Crown Development Application 0000005

I OBJECT wholeheartedly to the expansion of Haslar Immigration Removal Centre to increase capacity four-fold to 600 detainees. I do not think that you realise just how CLOSE our neighbouring homes are and how much this proposal will detrimentally affect our lives forever.

diagram 3 showing scale and raised platform

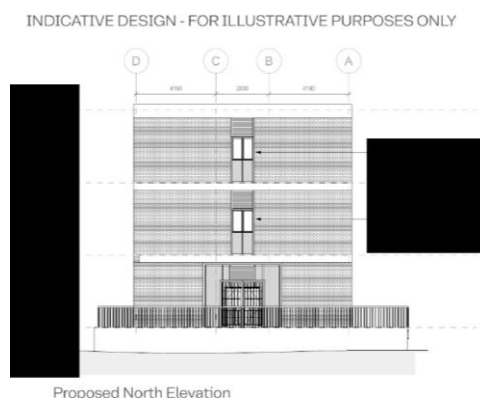
The plans state that the accommodation blocks are 3 storeys high, in fact they are 13 to 14m from ground level (12m in height raised 1.27m above ground level), which is the equivalent of 4.5 storeys (*diagram 3*). In addition, the dining hall and CASU blocks are described as single storey, but they are in fact 9m in height (the same height as a two storey home including the pitched roof) and they both have an additional floor clearly shown in the elevations (*diagram 4*). If they are single storey then they should be exactly that, not 9m high with a first floor! **This is deliberately misleading.**

Diagram 5 showing modular units for one floor of one accommodation block

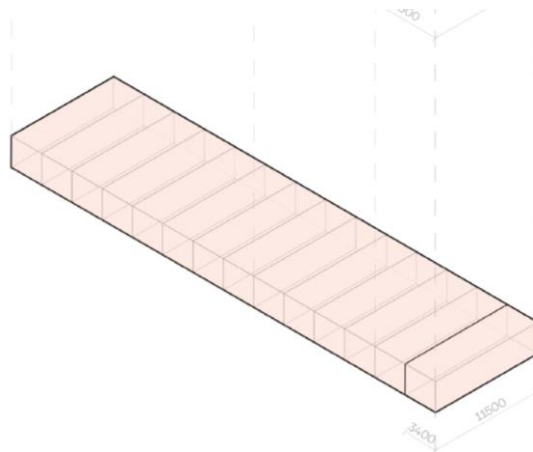
The accommodation blocks, dining hall and CASU will be ‘constructed’ of approximately 200 modular units, an absolute eyesore, not in keeping whatsoever with the surrounding area and not a design to be proud of, merely a way of cramming in as much accommodation as possible onto a restricted site as cheaply as possible, without care or consideration for the surrounding area and those who live there. (Diagram 5)

Each modular unit could be up to 16 m long and 3.5m wide, with a footprint of around 3,500 m² in phase 2 alone, all built on playing fields - **A GREENFIELD SITE!**
